Northrop Research and
Technology Center

9 May 1986

Dr. Herbert N. Berkow, Director
Standardization and Special
Projects Directorate
Division of PWR Licensing-B, NRR
U.S. Nuclear Regulatory Commission
Washington, DC 20555

SECTION I

Figure 1

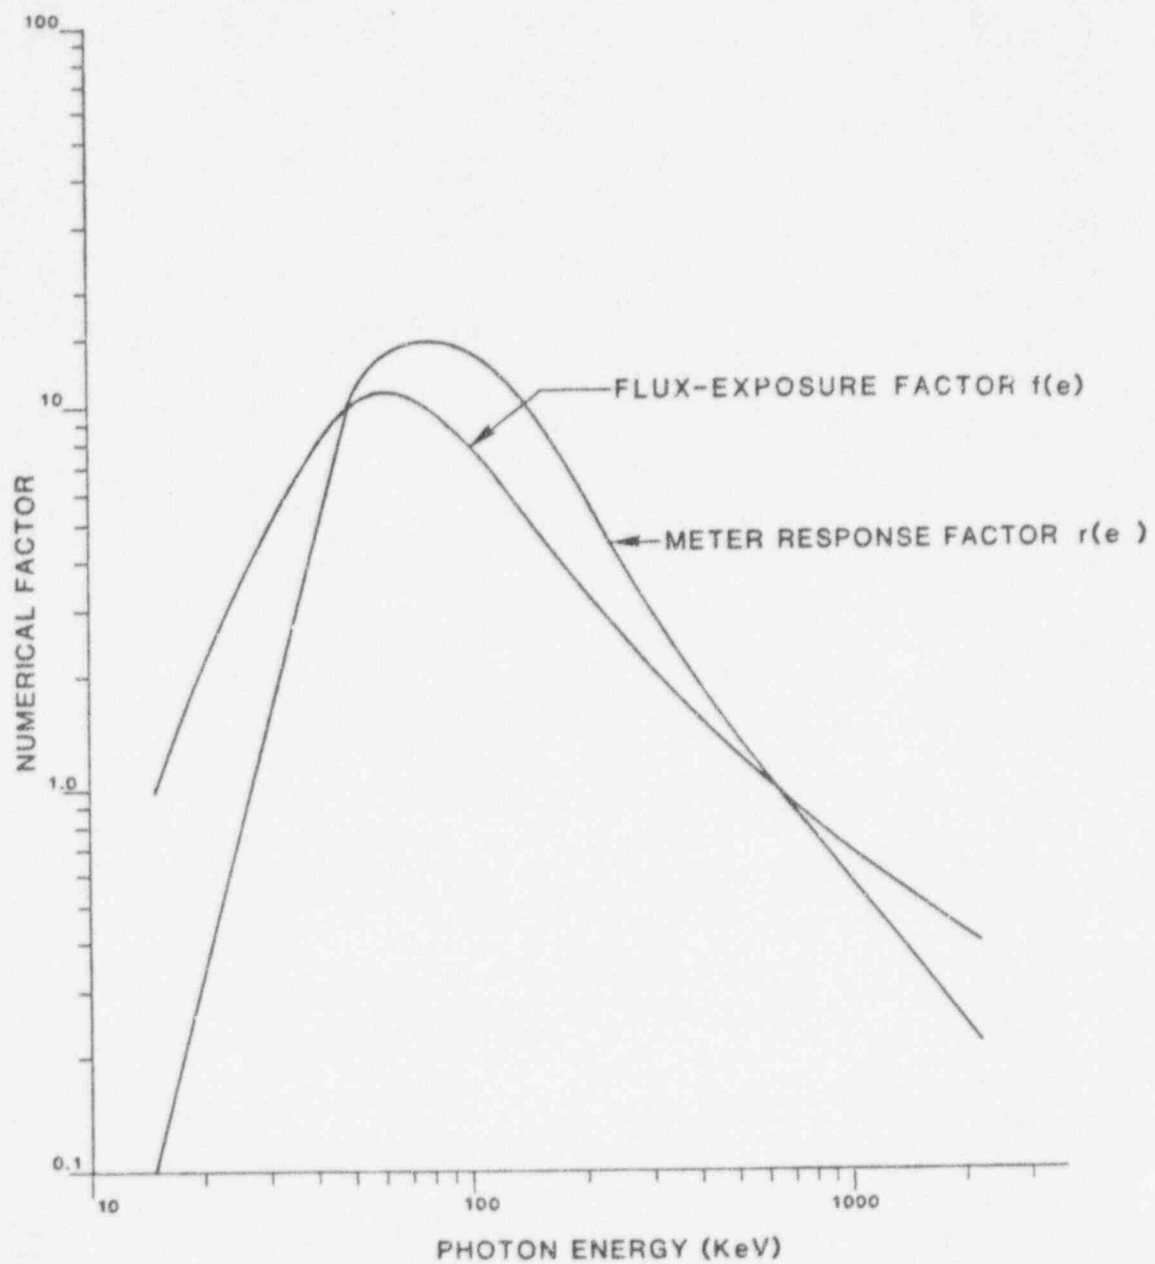
- (1) Radiation measurements were obtained by Northrop Corporation using a sodium iodide crystal which is calibrated for a certain source type and strength. The methods and standards used for calibration of this survey instrument were not specified in the final report. Please provide a detailed description of your calibration procedure and justify use of a scintillation detector, which is an energy dependent instrument, to measure dose rate with reasonable accuracy (e.g. $\pm 20\%$) over the wide range of energies expected in your surveys.

The factor $r(e)$ is plotted as a function of photon energy in Figure 1 (ref.2)

where x is the thickness of the attenuator. The experimental data corresponding to this expression appears in Table III and Figure 2. After normalizing so that $M_1 + M_2 = 1$, we find from Figures 1, 2 and 3:

where the function $f(e)$, flux-exposure factor, is plotted in Figure 1, and normalized to 1 for the Cesium gamma ray. Using this expression the values for exposure associated with each of the photon groups were calculated in Table V, column (7). Finally, using Equation (3) the meter readings corresponding to these exposures were calculated and listed in column (8). Summing the meter readings from each energy group

Figure 5a

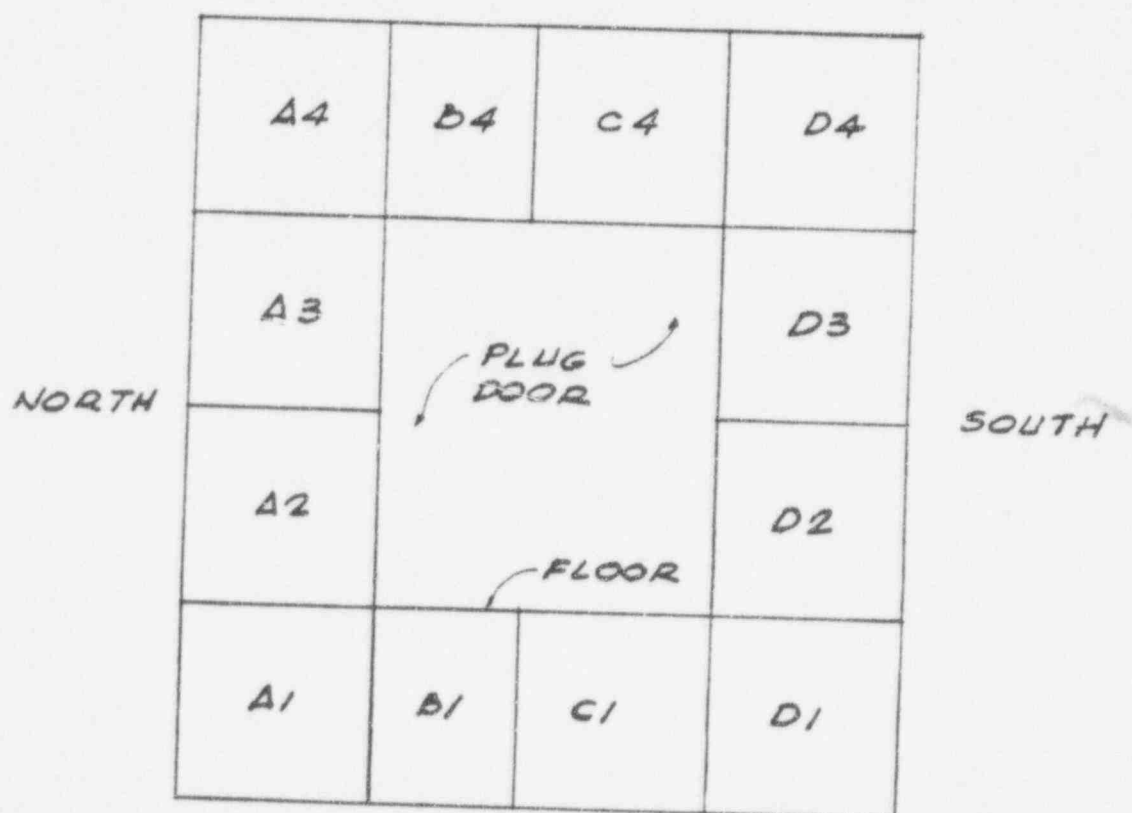
- (2) Your report indicates that your survey of the Exposure room was hampered by the small dimensions of the room, which resulted in your providing 4 pi readings versus measurements which would directly demonstrate satisfaction of the requirements of 5 uR/hr, at one meter from any planar surface. Your calculations indicated that the readings were close to background. However, because of the geometry problem, you dismantled the room and placed the resulting biological shield concrete rubble in a pile. Your survey of this pile also indicated readings close to background. However, during its final survey of your facility, the Region V staff found that the configuration of the concrete rubble pile precluded their obtaining the required final survey measurements with the available instrumentation.

Accordingly, we request that Northrop Corporation: (a) provide all the readings that were taken of the Exposure Room walls prior to dismantling, with and without shielding, (b) discuss the method used to determine "background" radiation and provide the respective data, (c) show from your measurement techniques and data that the contribution of dose rate from the surrounding walls could be subtracted from the relevant planar wall to provide the "close-to-background" dose rate from the planar wall, (d) physically redistribute the concrete rubble pile into a homogeneous configuration with as uniform and even a surface as possible and not more than about 1 foot deep. Measure the radioactive contamination levels at the surface and the radiation levels at one meter from the surface at a suitable number of locations.

Since the exposure room was classified as a "high potential" area the walls, floor, and ceiling were marked off in one-meter grids and 75% of the squares were selected for measurement by means of a random number generator. Figures 5a-e show schematic representations of the manner in which all surfaces were sectioned for the survey. Data on the west wall is missing because this is the wall which is shared by the pool and it was essentially eliminated when the window was removed.
